Subject: Submittal of Additional Information Concerning Remediation Activities at the
Westinghouse, Waltz Mill Site, Madison, Pennsylvania
License No., SNM-770, Docket No. 07000698

**Response to NRC Letter Dated August 10, 2001
Request for Additional Information
Concerning Remediation Activities**

**Waltz Mill Site
Madison, Pennsylvania**

**Response to NRC Letter Dated August 10, 2001
Westinghouse Electric Company, LLC
Request for Additional Information
Concerning Remediation Activities at the
Westinghouse Waltz Mill Site
Madison, Pennsylvania**

Attachment B
Time Trend Analysis
Environmental Groundwater Monitoring Program

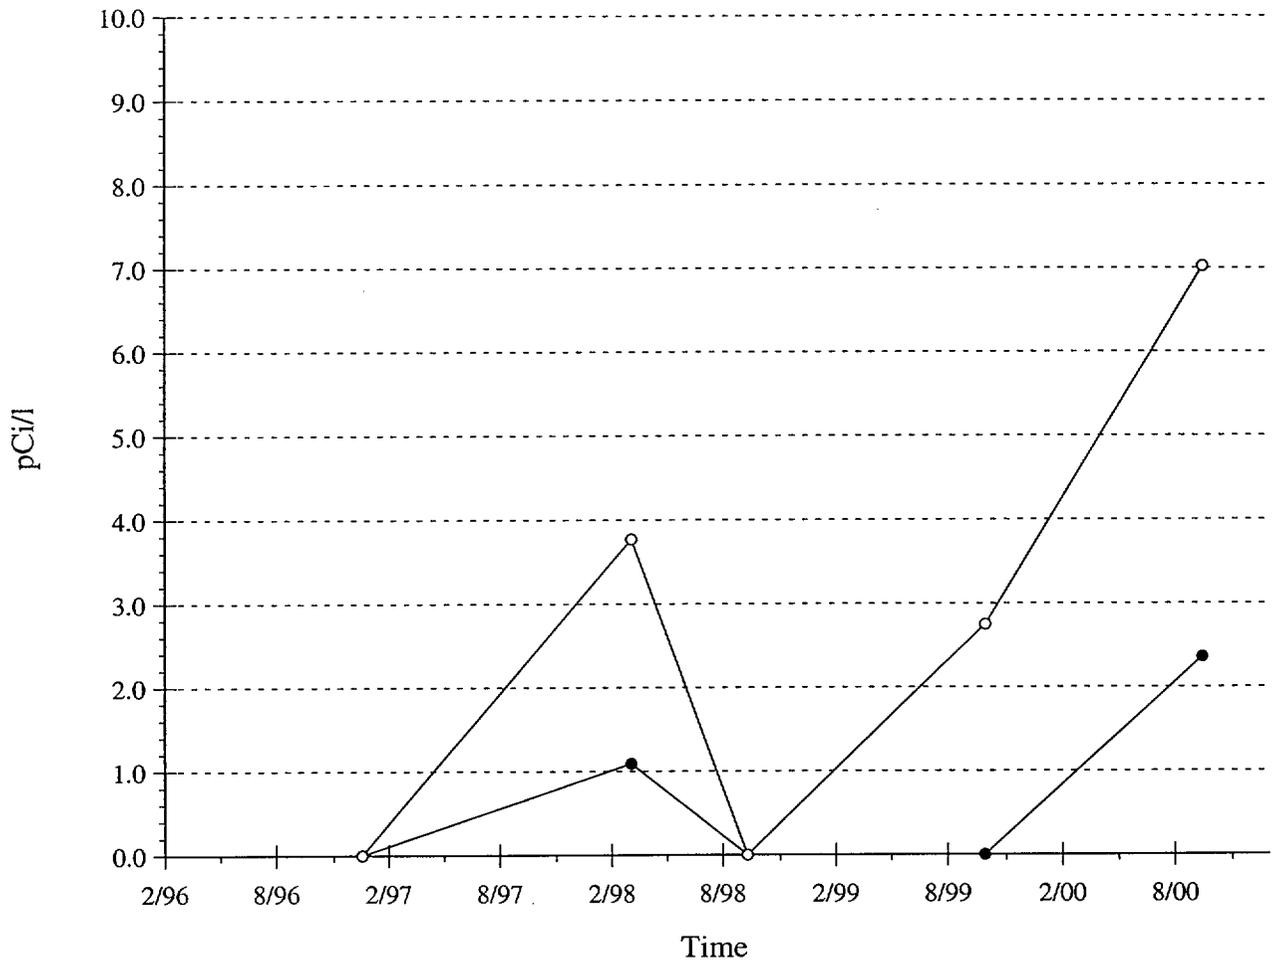
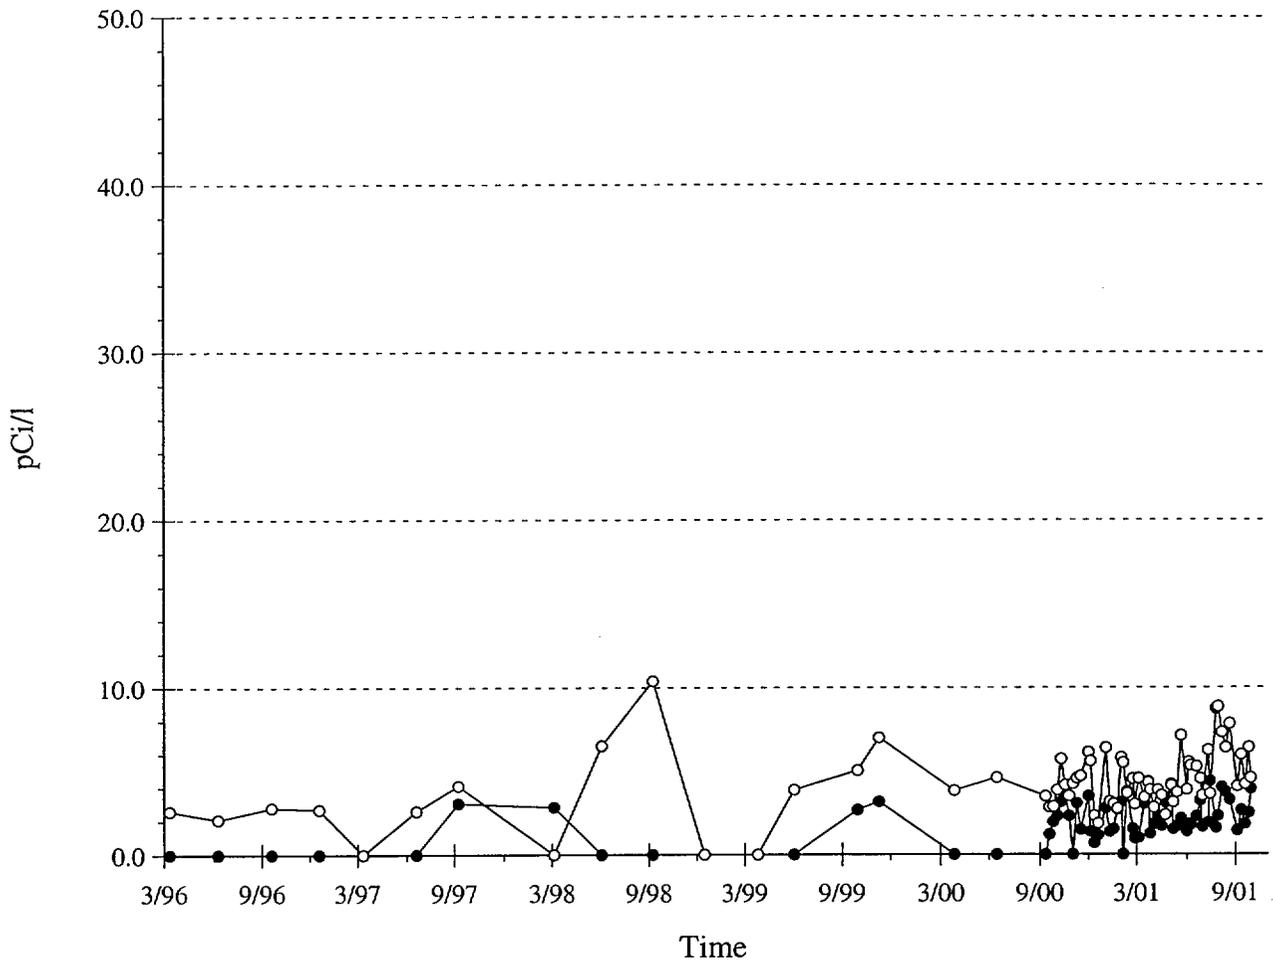
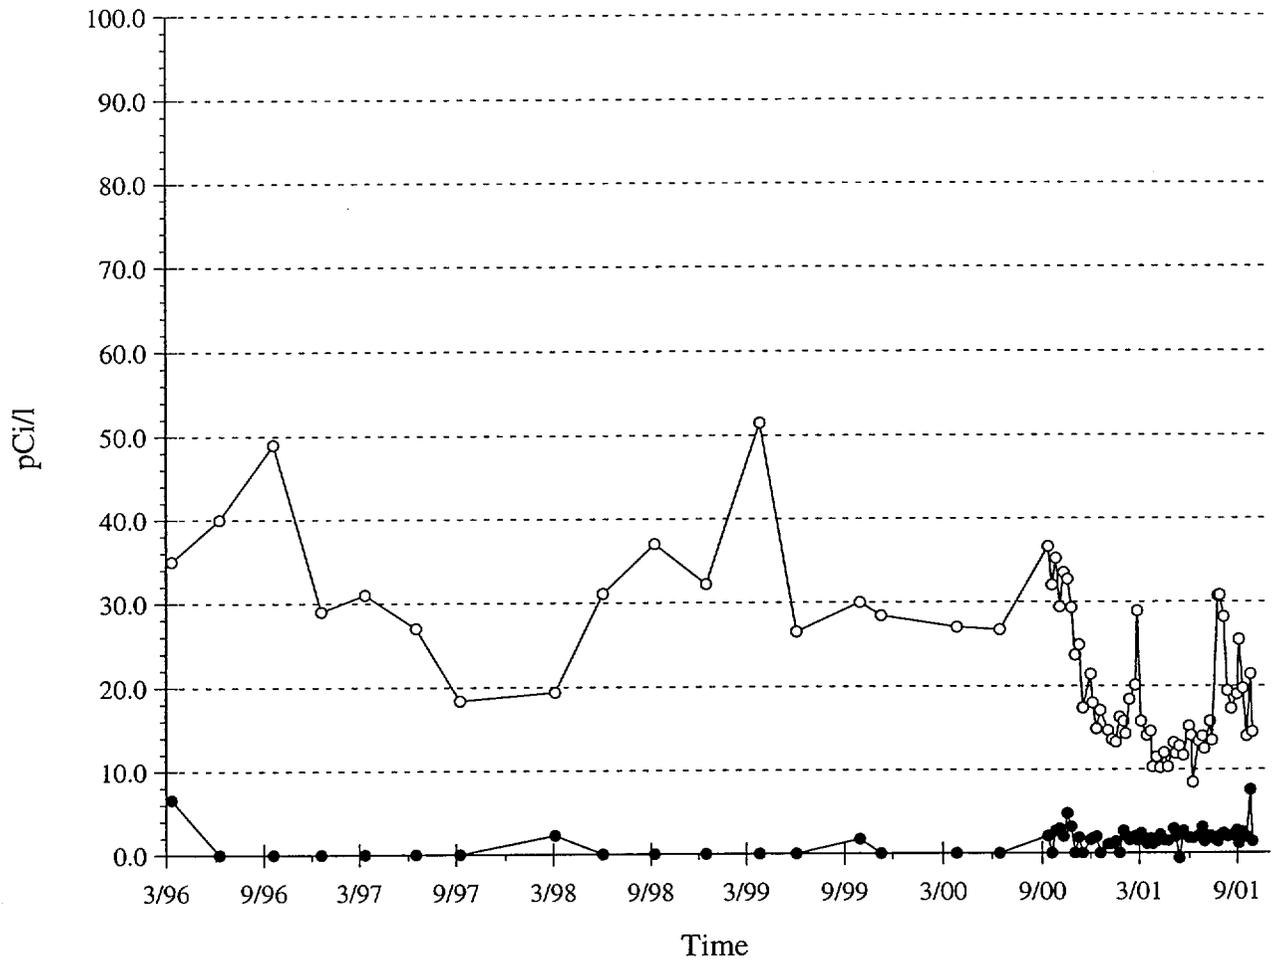
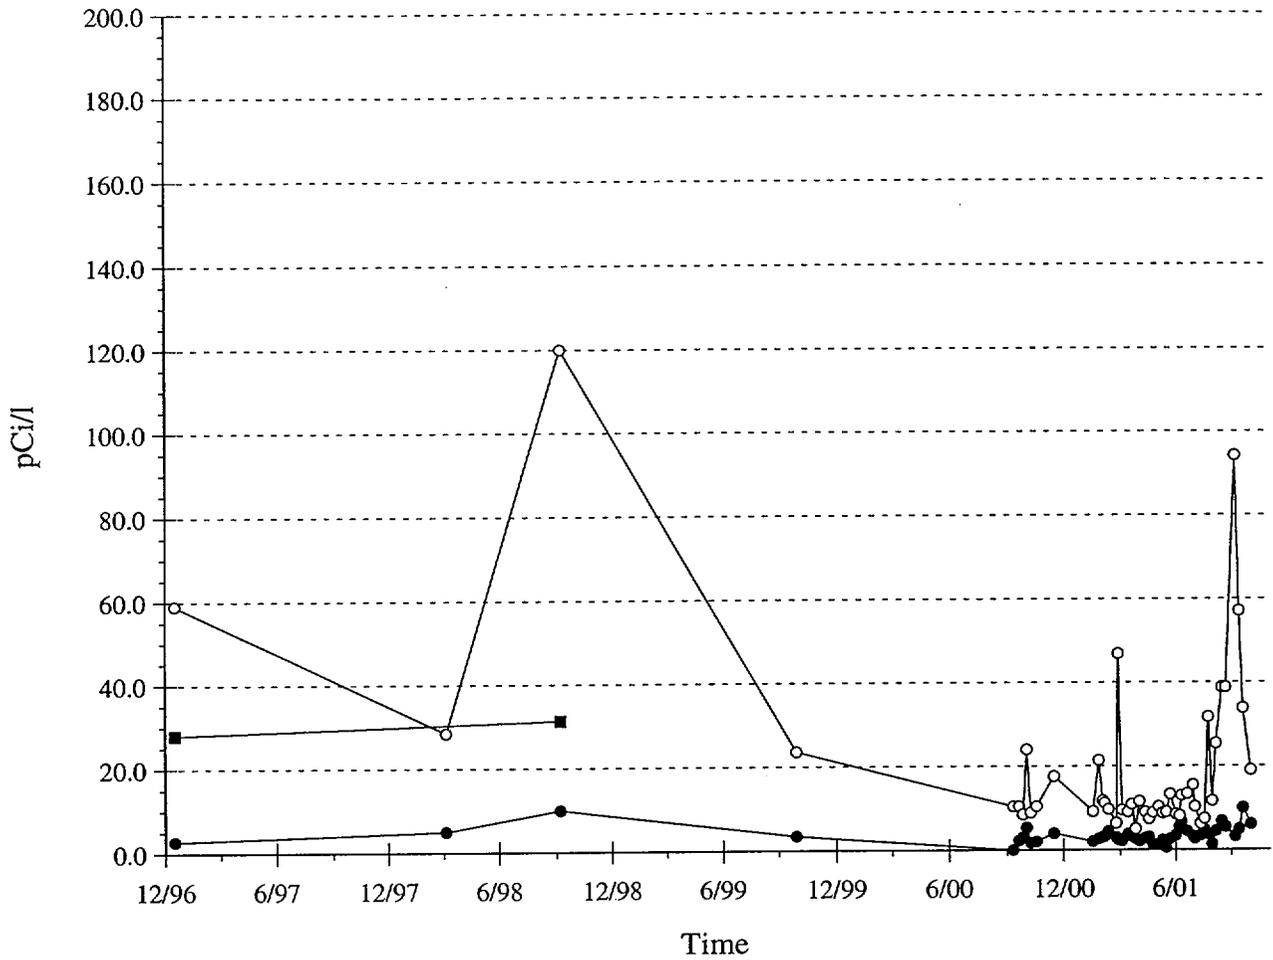
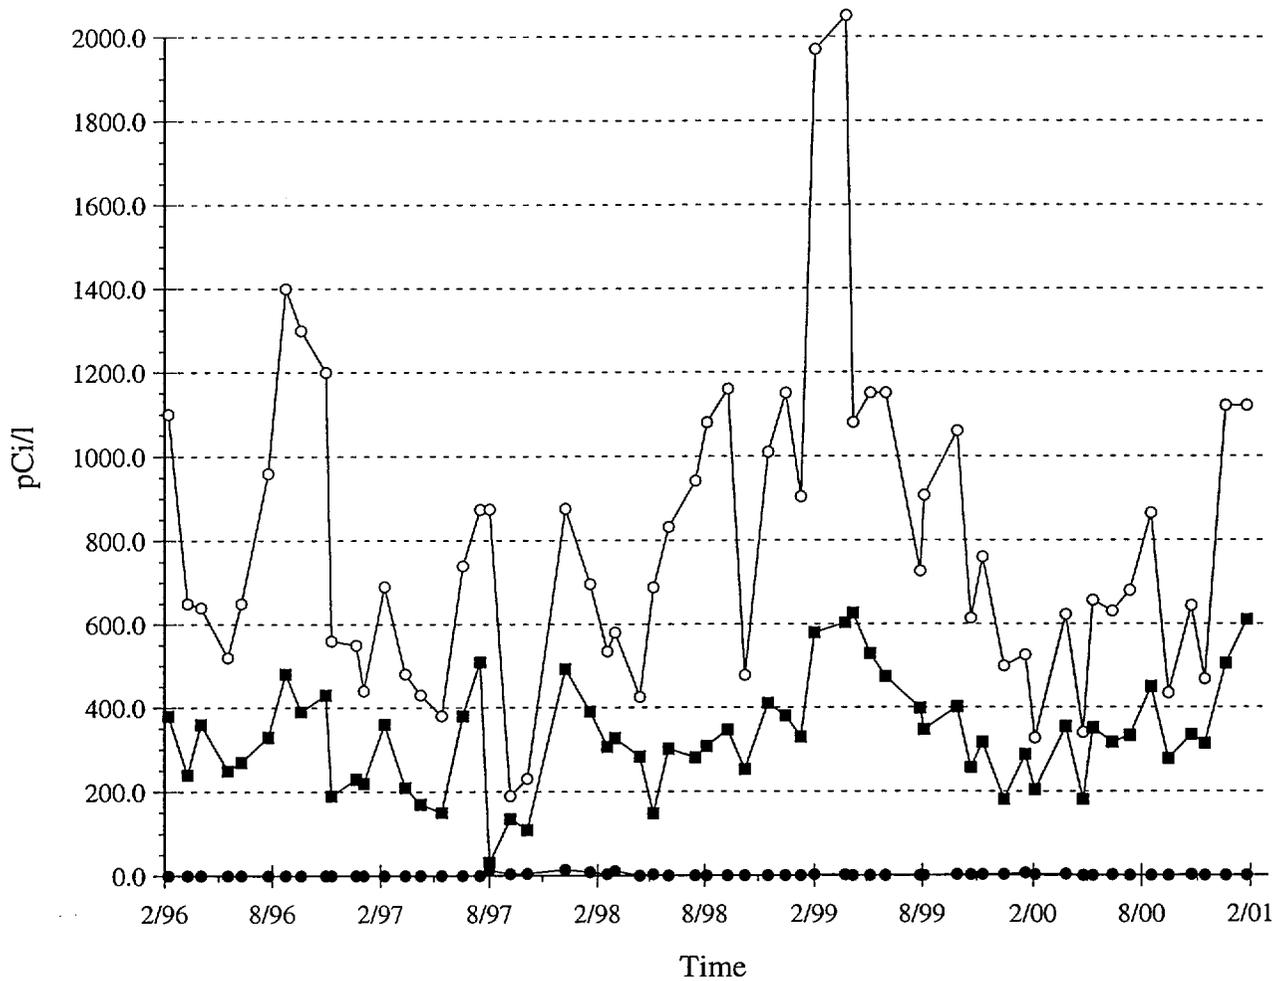
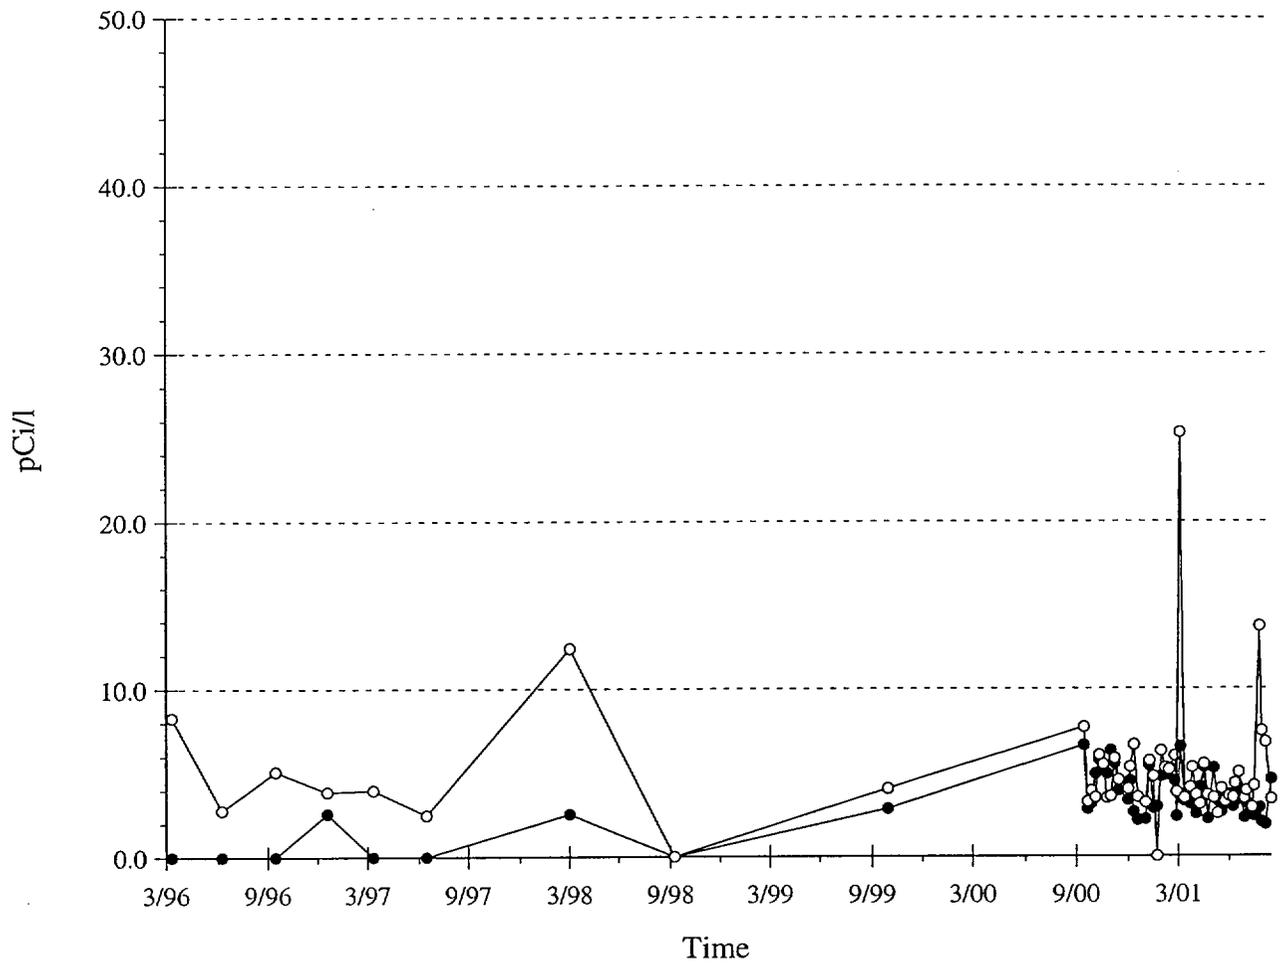
Question No. 4c: In order to evaluate radiochemical data trends for your onsite monitoring wells, please provide radiochemical data obtained since 1999. If possible, please provide the most current map of the groundwater plume configuration, compared to plume configurations measured in the past. Also, please explain the rise in the Sr-90 concentration in Well MW-5 during 1999 from 330 to 575 pCi/liter.

Historical data for Well MW-5 are presented in Attachment B. These data indicate that Sr-90 concentrations have fluctuated over time and that an increase in Sr-90 was observed on several sampling events. Well MW-5 was a remediation well. Because of low-flow conditions, the well was pumped periodically on a timer system. The reason for the fluctuation in concentration and, specifically, the rise in Sr-90 in 1999 could not be determined from the available data reviewed.
